COLORADO DIVISION OF RECLAMATION, MINING AND SAFETY
MINERALS PROGRAM INSPECTION REPORT
PHONE: (303) 866-3567

MINE NAME: Breeze Basin Sand & Gravel Pit	MINE/PROSPECTING ID#: M-2008-022	MINERAL: Sand and gravel	COUNTY: Moffat
INSPECTION TYPE: Monitoring	INSPECTOR(S): Dustin M. Czapl	INSP. DATE: March 28, 2012	INSP. TIME: 08:00
OPERATOR: 4B Land & Livestock LLC	OPERATOR REPRESENTATIVE: Gayle Lyman	TYPE OF OPERATION: 112c - Construction Regular Operation

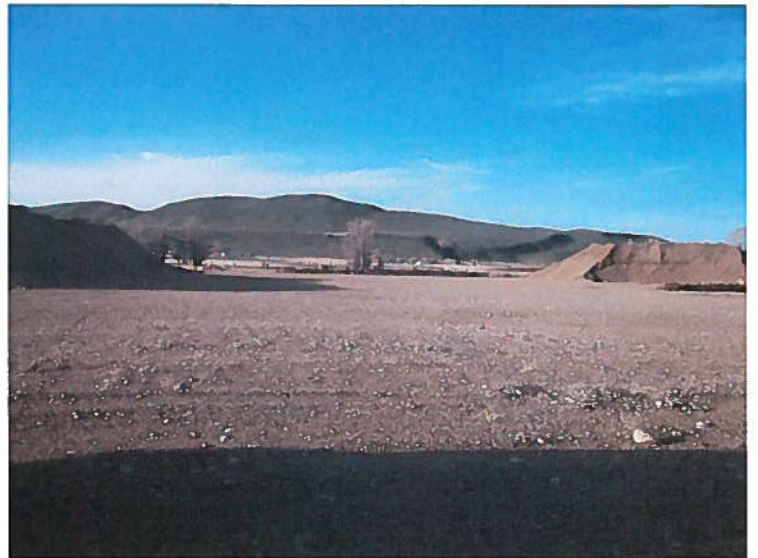
The affected area was marked by fencing and t-posts that were clearly visible and adequate to delineate the affected area boundary.

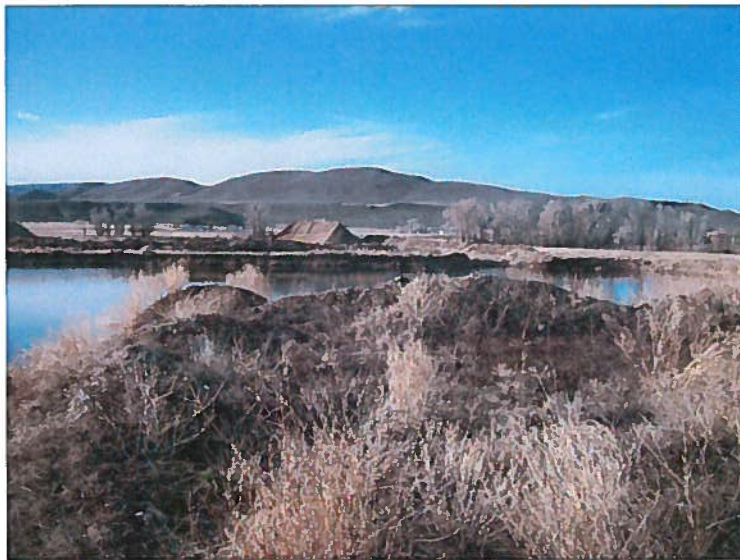
Mining at the site is progressing from north to south. All but the southern pit slope had been graded to approximately 3H:1V or less steep. The south pit slope had been mined at approximately 2H:1V. The pond area included approximately 6-7 acres during this inspection.
